# Request for Quotation

RFQ NUMBER  
 GSD106447

LINE	QUANTITY	UOP	CAT NO	ITEM NUMBER	UNIT PRICE	AMOUNT
ADDENDUM NO. 2						
THIS ADDENDUM IS ISSUED TO ADD THE FOLLOWING:						
1.) GSD106447 ADDENDUM NO. 2 DOCUMENTS, 4 PAGES.						
2.) GSD106447 QUESTIONS AND ANSWERS, 13 PAGES.						
3.) 15 CONSTRUCTION DRAWINGS.						
***** END OF ADDENDUM NO. 2 *****						
0001	1	LS		968-20		
CONSTRUCTION OF NEW OFFICE BUILDING, LOGAN, WV						
***** THIS IS THE END OF RFQ GSD106447 ***** TOTAL:

The following items revise the Bidding Document Drawings and Specifications dated June 10, 2010. Acknowledge receipt of this Addendum at the appropriate location indicated on the bid Proposal Form; failure to do so may be deemed a lack of bid responsiveness and can be cause for rejection of the Bid.

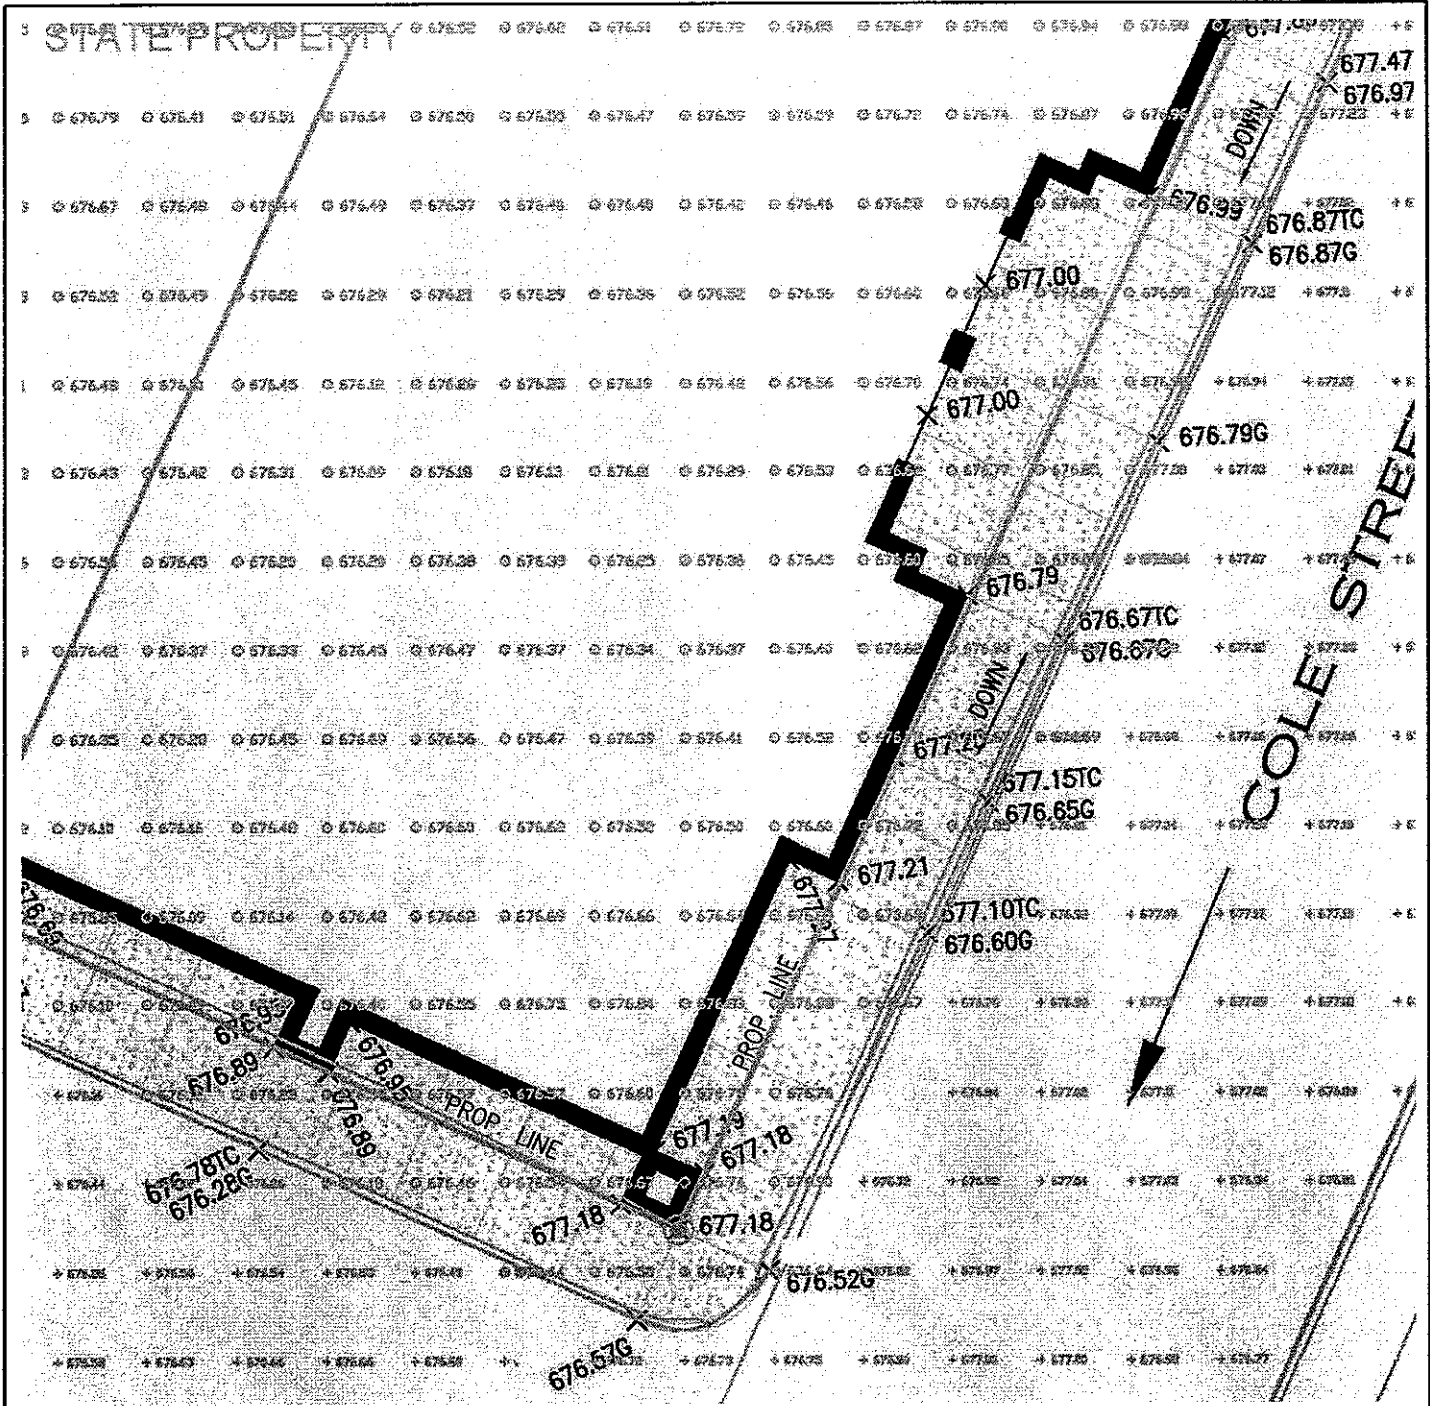
20. Alternate deduct – The description of work for the alternate deduct does not provide specific instructions on what work will be taken out, what work will be installed in place of the removed work and the exact location of the work effected. Please provide an itemized description of all work to be removed. All areas of work that will fall under this alternate deduct category and work that will be installed in lieu of the original work. At the moment, this alternate could be interpreted several different ways.

**Answer: See attach Sketches #AD-1C-5, AD-1C-6, AD-1C-7, AD-1C-8, AD-1C-9, AD-1C-12, and AD-1C-13.**
21. Please provide a detail/dimension for the perimeter insulation detail. Additionally, does the perimeter insulation install vertically @ the perimeter grade beam? One detail shows this with no dimension and several others show it to the top of the grade beam?

DRAWING No.  
 AD-1C-10

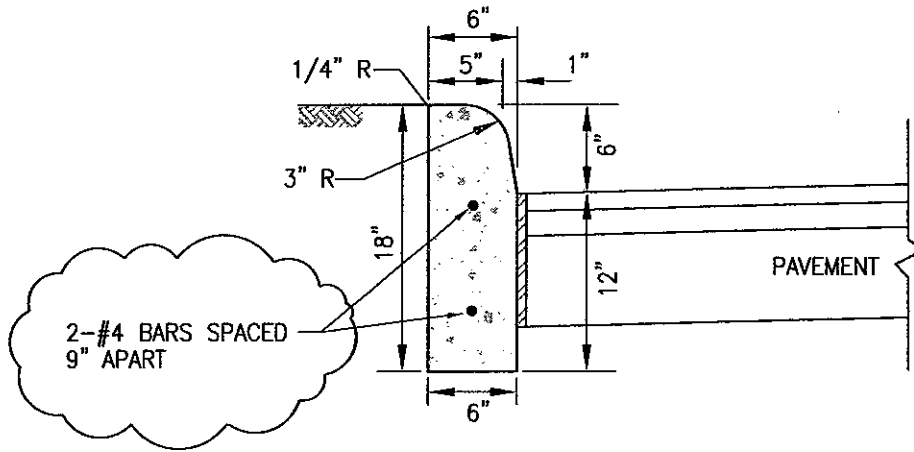
58. C3.01 does not show the areas of asphalt patch for the underground electrical for service entrance.  
**See sketch AD-1C-10 and sketch AD-1C-11.**
59. Is the CATV work on sheet C3.01 to be performed if the Plaza work is eliminated? The note on the 12"X18" quazite box does not specify which circuits is to be roughed – in?
